Kewaunee Power Station NRC Agenda Setting Meeting

9/15/2009

E13a-e: CFD modeling of containment flow

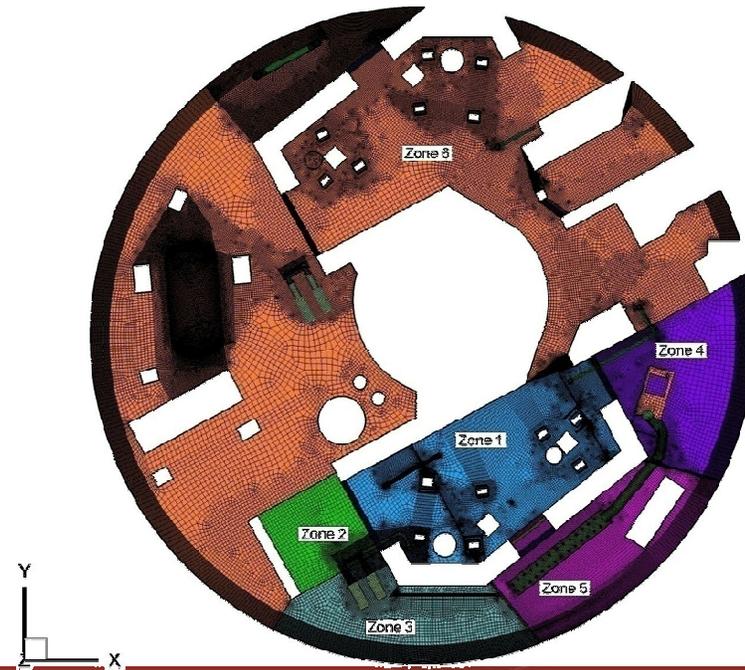
- Simulations were conducted using Fluent and followed the standard calculation methodology
- The standard k- ϵ model was used for turbulence calculations
- Debris transport calculations were conservatively performed at the water level for the start of recirculation
- High transport fractions were obtained for most zones up to a tumbling velocity of 0.2 ft/sec

E13a-e: CFD modeling of containment flow

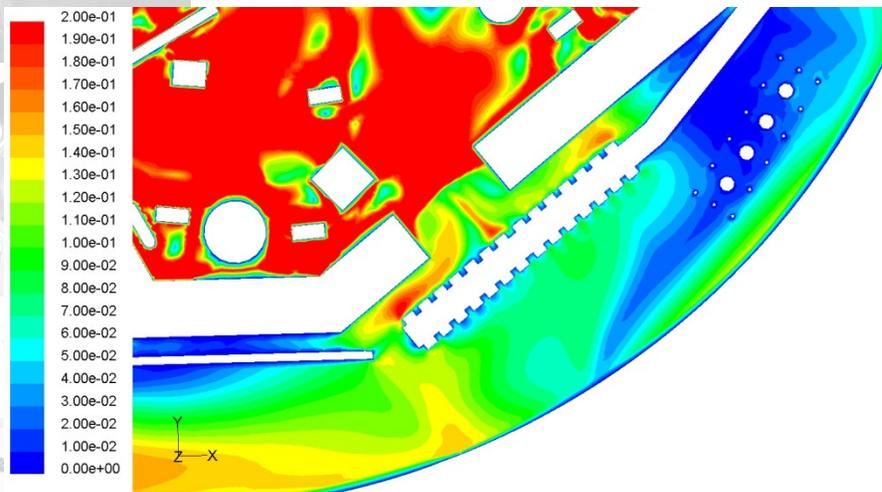
- Detailed accounting was performed to model spray and break flow drainage into the recirculation pool
- Concentrated sources of falling water were treated ideally converting all water potential energy into kinetic energy
- The debris interceptor curb was modeled with few simplifying assumptions
- No assumptions with regard to debris interceptor debris loading were necessary
- No credit was taken for lift-over-curb transport limitations over the debris interceptor curb

E15: Turbulence in containment and flume / test configuration

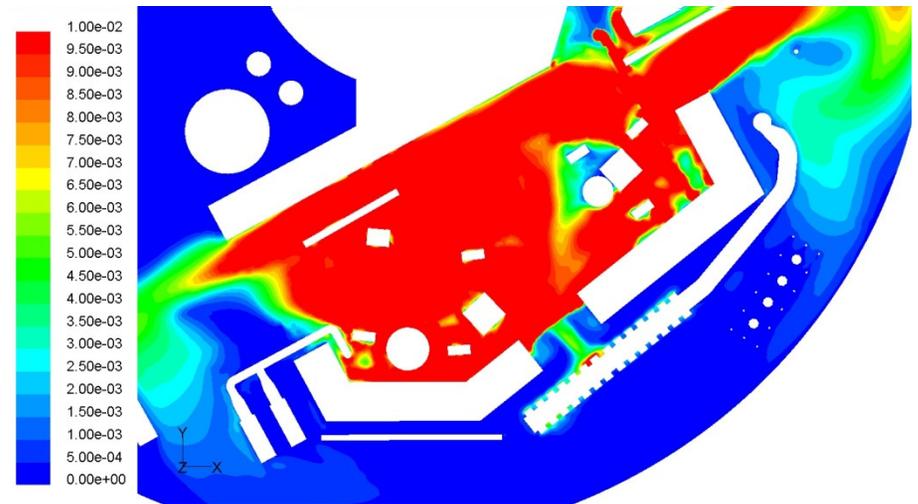
- Flume configuration based on long-term recirculation conditions
 - Achieved 14 minutes after recirculation start
- Water level in containment for analysis and test maintained at 40.5”
 - 40.5” is water level for the start of recirculation
 - Actual water depth is more than 2 ft higher for long-term recirculation
- Velocity and turbulence levels in vicinity of strainer are low
- Containment structure divides break flow into three sources distributing break flow momentum

E15: Turbulence in containment and flume / test configuration

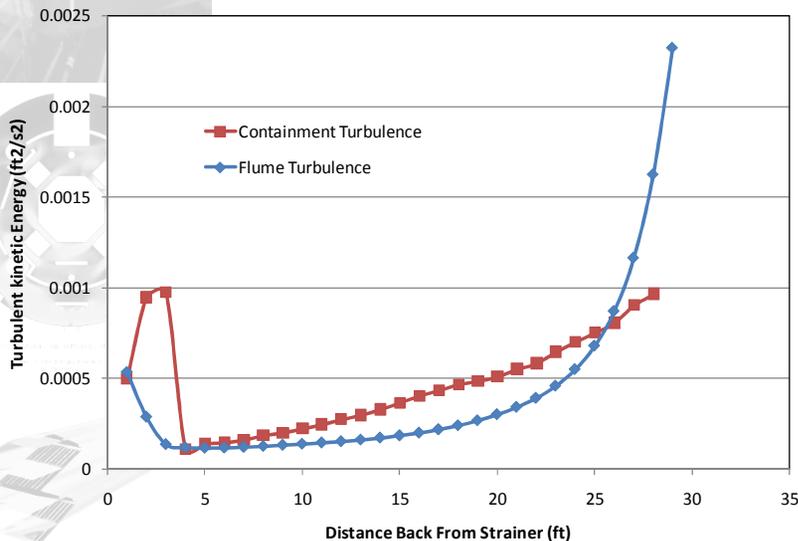
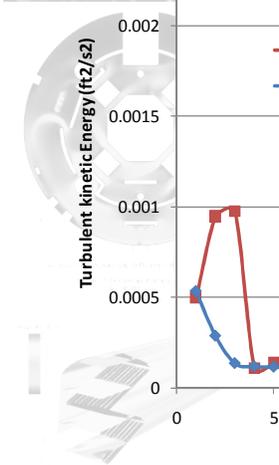
- Debris interceptor, despite its low height blocks most break flow from reaching strainer
- Flume Reynolds numbers are in the turbulent range
- Flume effective turbulence is on par with that calculated in containment
- Turbulence levels calculated in containment correspond to a maximum of 0.02 ft/sec RM

E16: Pool fill transport & distance traveled by debris

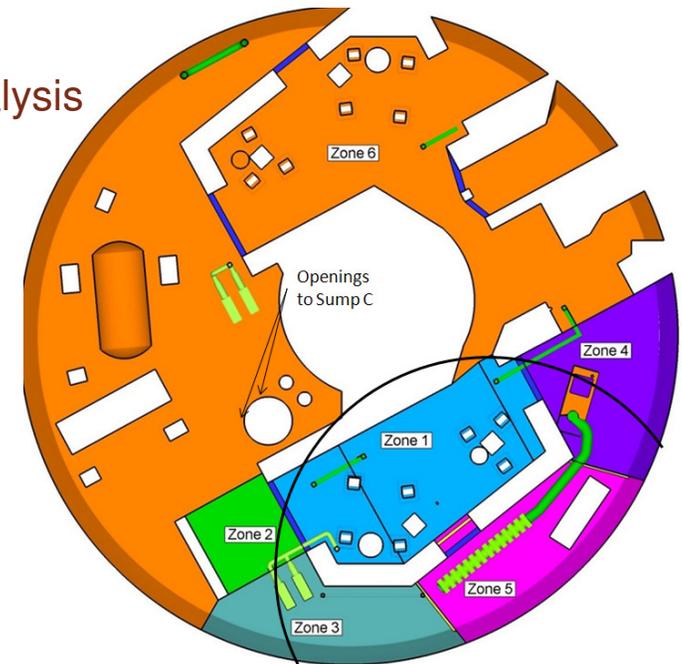
- Preferential pool fill transport is limited except during sump C fill-up
- Sump C fill-up preferentially causes debris to move away from strainer bank
- No credit for this transport is taken in the analysis
- The average distance traveled by debris is greater than 30' when considering calculated zone exit flow splits
- TempMat calculated transport fraction was increased by 20% of debris generated for conservatism in determining test quantity
- Transport testing at Alden showed 3x – 4x approach velocity profile only yielded partial transport of TempMat smalls.
